Proposed Modification to Design Basis: Groundwater Discharge Permit No. GW1810162

David List, P.E.
Golder Associates Inc.

Infiltration System: Existing Permitted Design versus Proposed Modified Design

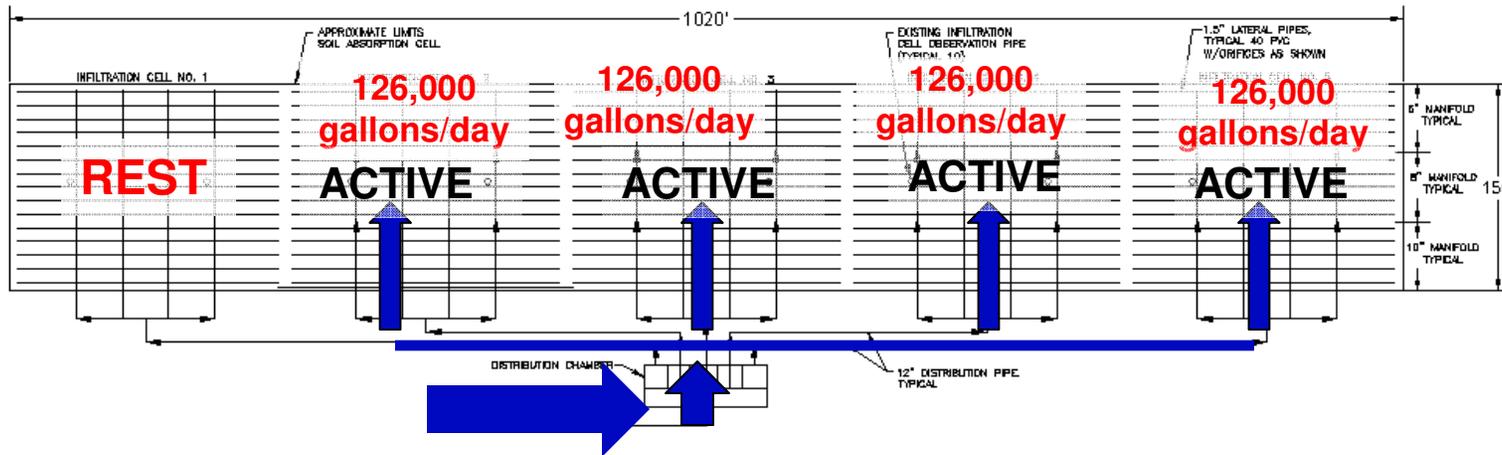
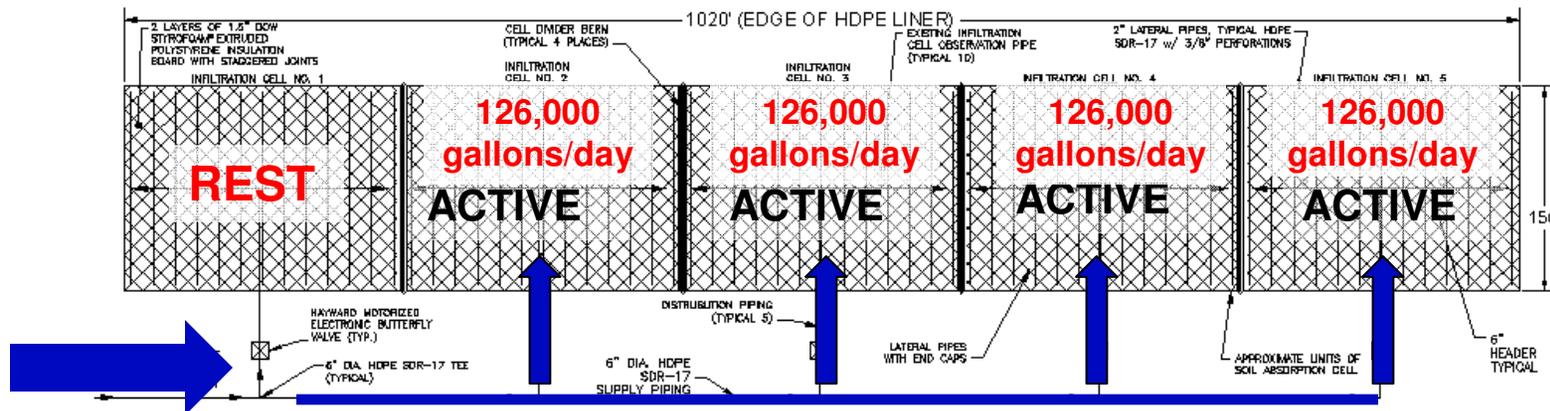
Existing Permitted Designed Treated Water Infiltration System

Proposed Modified Designed Treated Water Infiltration System

- ❑ Water is delivered to the infiltration system in a slightly different manner namely eliminating the distribution chamber and replacing it with individual valves and flow meters.

Infiltration System: Existing Permitted Design versus Proposed Modified Design

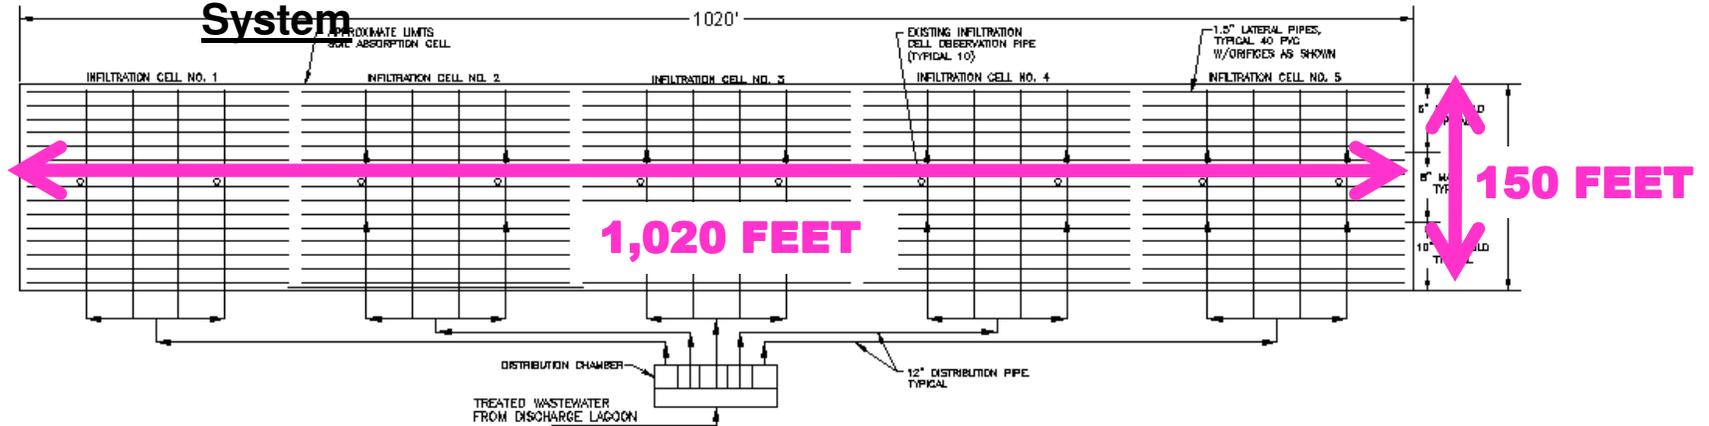
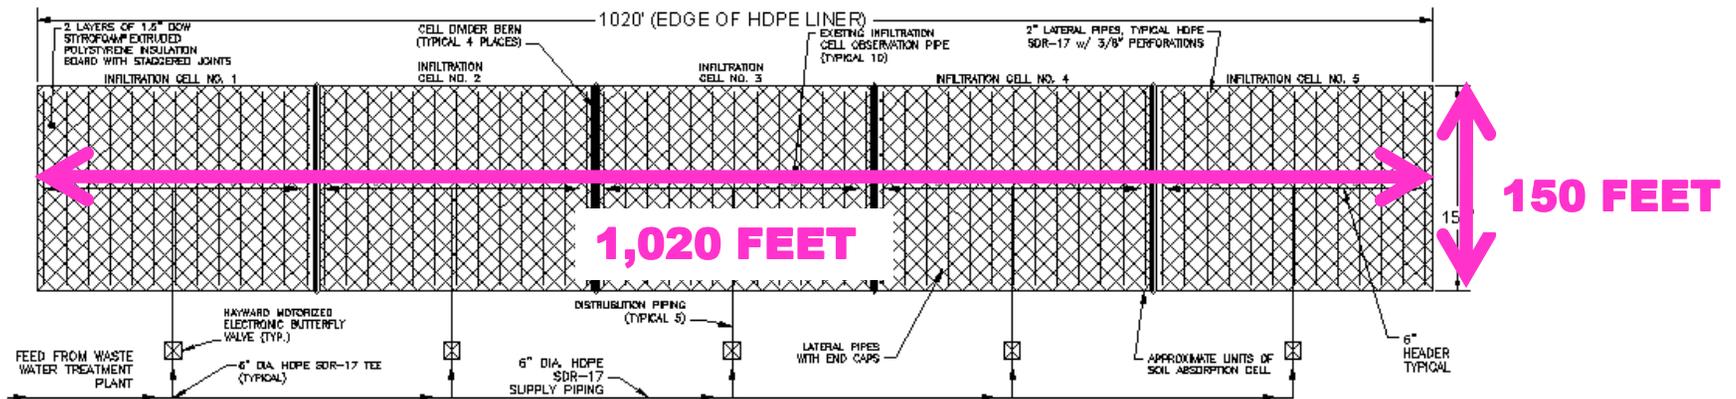
Existing Permitted Designed Treated Water Infiltration System

Proposed Modified Designed Treated Water Infiltration System

- ❑ The diameter of the laterals has been increased from 1.5 inch PVC to 2 inch HDPE.

- ❑ The length of the lateral distribution pipe has been decreased.

Infiltration System: Existing Permitted Design versus Proposed Modified Design

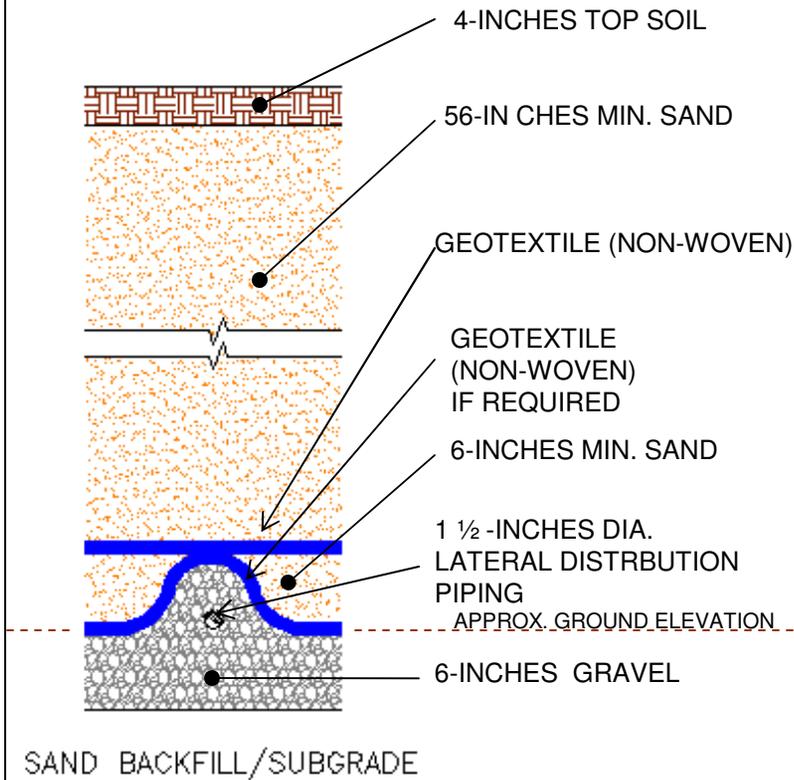
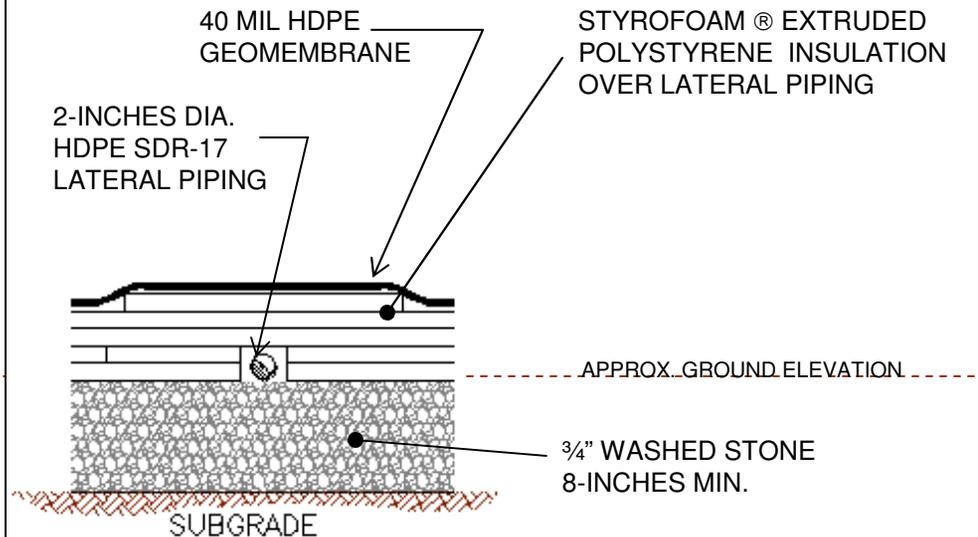
Existing Permitted Designed Treated Water Infiltration System – Cross-Section

Proposed Modified Designed Treated Water Infiltration System – Cross-Section

- ❑ The cover system has changed from several feet of soil to synthetic insulation overlain by a geomembrane.
